DOMINION ENERGY KEWAUNEE, INC.
KEWAUNEE POWER STATION
SUPPLEMENT AND RESPONSE TO REQUEST FOR ADDITIONAL INFORMATION:
LICENSE AMENDMENT REQUEST 236, AUTOMATIC OPERATION OF
TRANSFORMER LOAD TAP CHANGERS (TAC NO. ME4011)

**RESPONSE TO REQUEST FOR ADDITIONAL INFORMATION:
LICENSE AMENDMENT REQUEST 236
AUTOMATIC OPERATION OF TRANSFORMER LOAD TAP CHANGERS**

**CS-SI-5R6R-6-ICS-0-2 (Bus Voltages TAP 3R)
Minimum Voltage for a 1.465% Pre-trip to Post Generator Trip Voltage Drop**

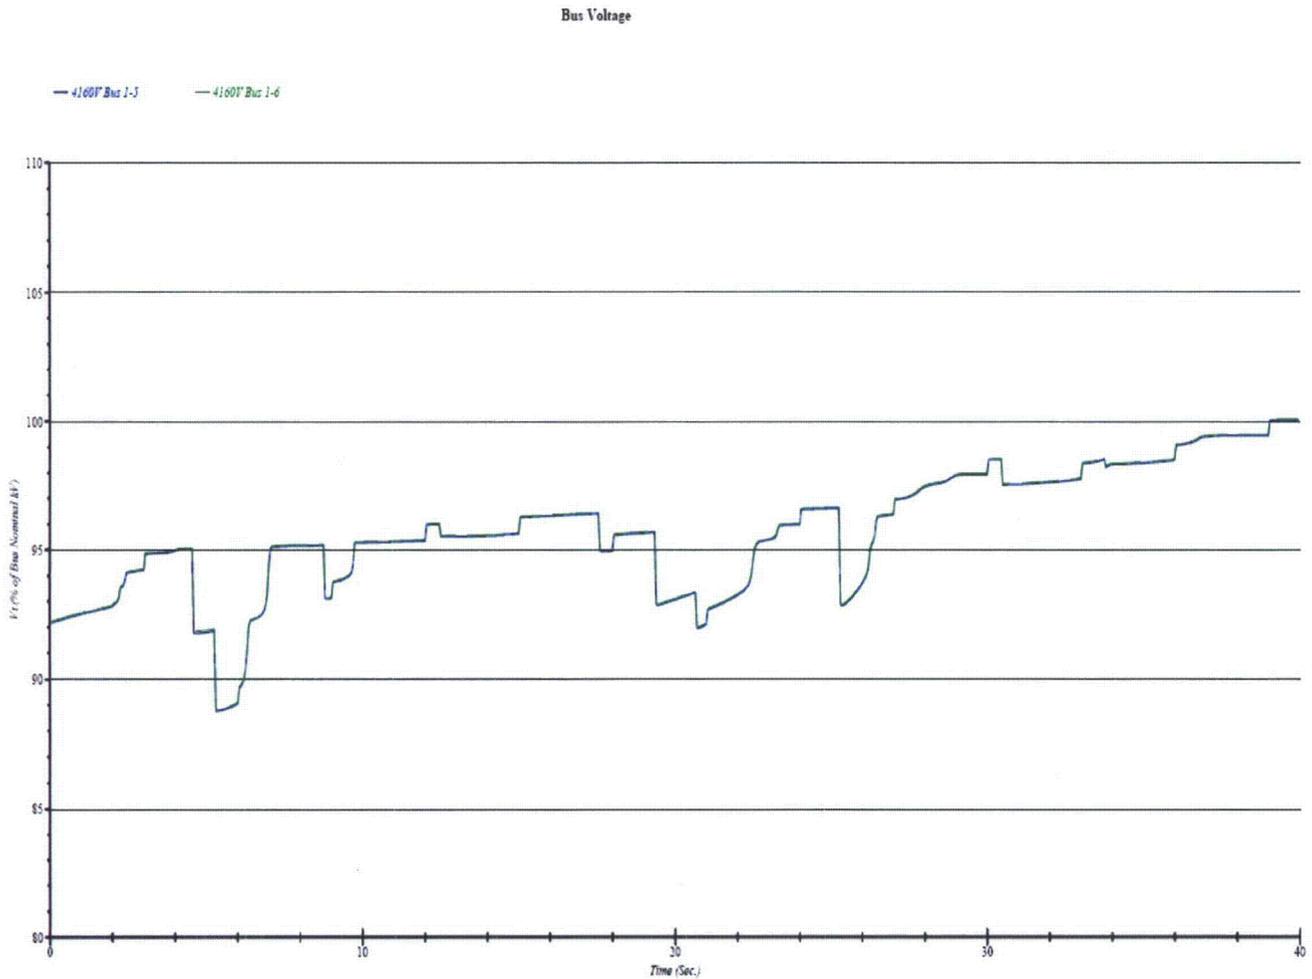
Bus 1-5 is normally supplied from the TAT and Bus 1-6 is normally supplied from the RAT. Thus, no bus transfer is required for the engineered safety features in the event of a unit trip. The plant was designed with an automatic bus transfer feature. Verify that a single failure of the bus transfer scheme will not result in transfer of the Busses 1-5 and 1-6 to a single source of offsite source during a design basis event.

ETAP runs were performed to verify the initial tap position (post event) based on the pre-event tap position (prior to generator trip and SI sequence initiation); and, to establish that the degraded voltage relaying (DVR) would not actuate. Based on analyses performed by American Transmission Company (ATC – transmission operator for KPS), if KPS loses both of its 345kV lines or both T10 and T20 345/138kV transformers (related to the two 345kV switchyard lines); or, if both Point Beach Nuclear Power (PBNP) units are unavailable; or, if Q303 (345kV) and F84 (138kV) transmission lines are both out of service, then it is possible that the maximum change in switchyard voltage due to a KPS unit trip would be from 1.82% to 2.76%. Therefore, for the above

Absence of these worst case conditions would result in a much smaller resultant voltage change. The ATC analyses show that other possible limiting switchyard configurations would result in a maximum voltage drop of 1.465% or less. DEK plans to request that ATC provide a programmed load/voltage forecast warning indication to KPS upon the system forecasting a 1.46% or larger drop in voltage at KPS (due to KPS unit trip). In the event that a larger than 1.46% drop in voltage is forecasted, KPS operators have the capability to manually transfer Buses 1-3 and/or 1-4 to the RAT. This anticipatory transfer would cause the upstream RAT supply transformer (RST) LTC to raise taps and account for the additional Bus 1-3 and/or Bus 1-4 load prior to the trip and thereby decrease the 4kV voltage drop associated with the non-safety related bus transfer at the time of a unit trip. Thus, DVR actuation would not be expected to occur, and the offsite power source (RAT supply) would be maintained.

Voltage profile graphs of the associated ETAP analyses results are provided (for information) in Figures 1 through 7 below. These graphs show that voltage does not decrease below 95% of nominal bus voltage for more than 6 seconds. Although the DVRs themselves actuate, their associated time delay relays do not time out. Thus, no bus stripping signal is initiated and offsite power remains available.
